Item No: 3.5
Title: Winney Bay
Department: Environment and Planning

9 September 2019 Ordinary Council Meeting

RNSW1211 – Winney Bay Cliff Top Walk Change Request 01 Version 2.0

Change Request CR01

Figure 4 Concept plans, side view, of the viewing platform.

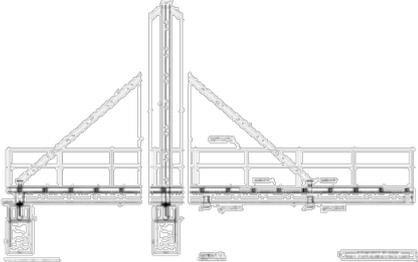
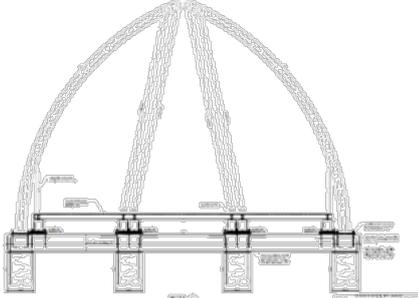
INSW considers that the bridge spanning the chasm and the north facing lookout are integral to the project. The proposed changes to these elements, and the associated shortening of the all abilities access to the lookout, would fundamentally change the nature of the project. On this basis, INSW does not support them.

INSW considers that the bridge spanning the chasm and the north facing lookout are integral to the project. The proposed changes to these elements, and the associated shortening of the all abilities access to the lookout, would fundamentally change the nature of the project. On this basis, INSW does not support them.

If Council wishes to continue with the project, noting the requirements to include the bridge spanning the chasm and the north facing lookout, the NSW Government grant under the Regional Growth Environment Tourism Fund is still available.

Figure 8: An artist's impression of the community selected design of the bridge.

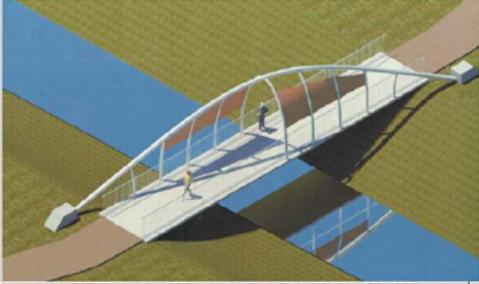
- The Bridge** has been deleted.

- Impact:** Full accessibility will not be achieved beyond the viewing platform's new location; however accessibility will still be significantly improved along the informal track enhancing access for a greater variety of user groups. The recently installed concrete stairs at the northern extremity of the project site would constrain wheelchair access at that point. (i.e. wheelchair access is not possible for the full extent of the walk through the reserve on areas of path already completed).
